SERVICE BULLETIN

OCTOBER 23 1997

PRODUCT UPDATE: FUEL TANK, HEAT SHIELD

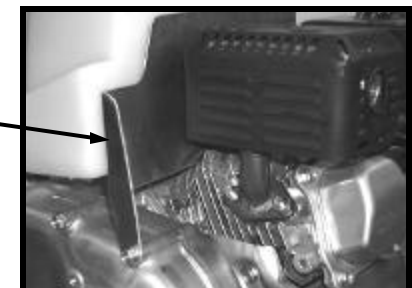
The fuel tank area at rear of muffler becomes soft and/or develops a leak.

The muffler deflector may restrict exhaust flow from muffler causing excess heat which can distort fuel tank and in extreme cases contact muffler. If this should occur, fuel tank can become soft and could result in a rupture [A].

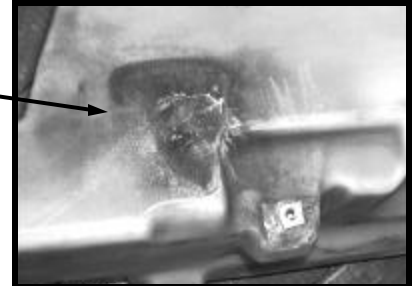
Muffler guard cracking from engine vibration.

Install Flat Bushing Part# 009071 Qty [1] immediately [C].

00877 - Bolt, 1/4-20x1 Qty[1]

00948 - Nut, 1/4-20 z Qty [1]

00966 - Washer, 1/4-z Flat Qty [1]
